PIC24FJ64GB004 Family Silicon Errata and Data Sheet Clarification

The PIC24FJ64GB004 family devices that you have received conform functionally to the current Device Data Sheet (DS39940D), except for the anomalies described in this document.

The following typographic corrections and clarifications are to be noted for the latest version of the Device Data Sheet (DS39940D):

FIGURE 2-3 FREQUENCY vs. ESR PERFORMANCE FOR SUGGESTED VCAP

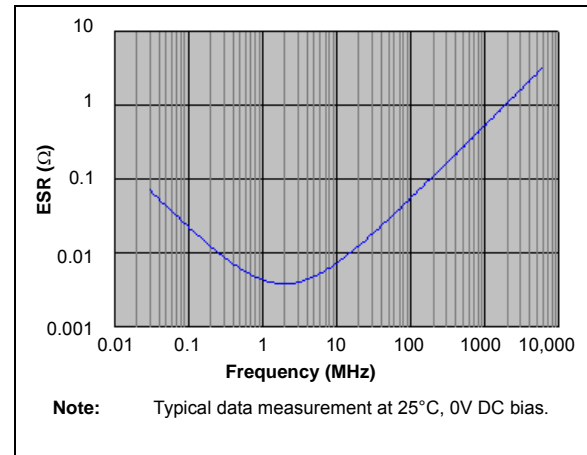
Section 2.4 Voltage Regulator Pins (ENVREG/DISVREG and VCAP/VDDCORE) has been replaced with a new and more detailed section. The entire text follows:

When the regulator is enabled, a low-ESR ($< 5\Omega$) capacitor is required on the VCAP/VDDCORE pin to stabilize the voltage regulator output voltage. The VCAP/VDDCORE pin must not be connected to VDD and must use a capacitor of 10 μF connected to ground. The type can be ceramic or tantalum. Suitable examples of capacitors are shown in [Table 2-1](#). Capacitors with equivalent specifications can be used.

Designers may use [Figure 2-3](#) to evaluate ESR equivalence of candidate devices.

FIGURE 2-4 DC BIAS VOLTAGE vs. CAPACITANCE CHARACTERISTICS

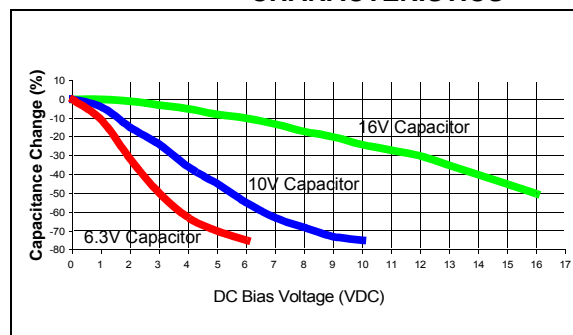
In addition to temperature tolerance, the effective capacitance of large value ceramic capacitors can vary substantially, based on the amount of DC voltage applied to the capacitor. This effect can be very significant, but is often overlooked or is not always documented.

A typical DC bias voltage vs. capacitance graph for 16V, 10V and 6.3V rated capacitors is shown in Figure 2-4.

When selecting a ceramic capacitor to be used with the internal voltage regulator, it is suggested to select a high-voltage rating, so that the operating voltage is a small percentage of the maximum rated capacitor voltage. For example, choose a ceramic capacitor rated at 16V for the 2.5V core voltage. Suggested capacitors are shown in Table 2-1.

FIGURE 29-1: PIC24FJ64GB004 VOLTAGE-FREQUENCY GRAPH (INDUSTRIAL)

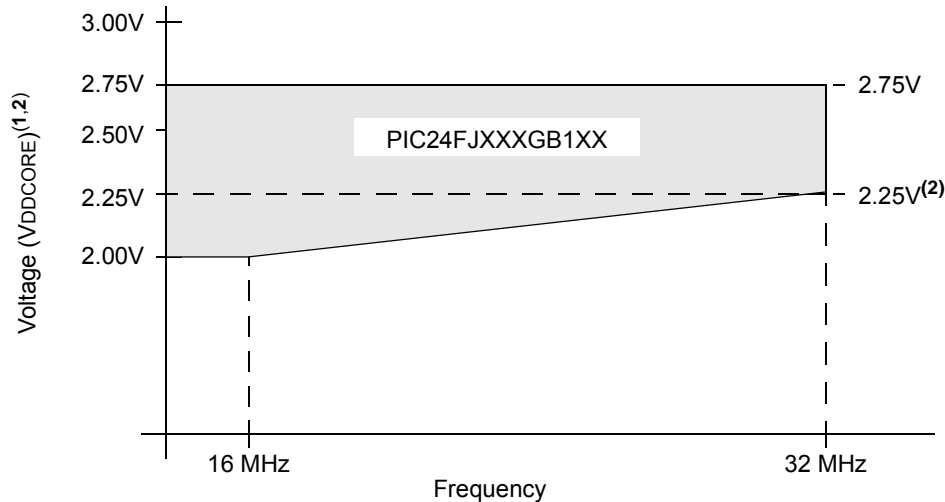
Figure 29-1 (“PIC24FJ256GB110 Family Voltage-Frequency Graph”) is amended by adding an additional footnote. The updated figure is shown below (changes in **bold**; bold in original removed for clarity).

For frequencies between 16 MHz and 32 MHz, $F_{MAX} = (64 \text{ MHz/V}) * (V_{DDCORE} - 2V) + 16 \text{ MHz}$.

- Note 1:** When the voltage regulator is disabled, VDD and VDDCORE must be maintained so that $V_{DDCORE} \leq V_{DD} \leq 3.6V$.
- 2:** When the USB module is enabled, VUSB should be provided at 3.0V to 3.6V, while VDDCORE must be 2.35V. When the USB module is not enabled, the wider limits shaded in grey apply. The voltage on the VUSB pin should be maintained at (VDDCORE – 0.3V) or greater; optionally, the pin may be left in a high-impedance state when the USB module is not in use, but doing so may result in higher I_{PD} currents than specified.
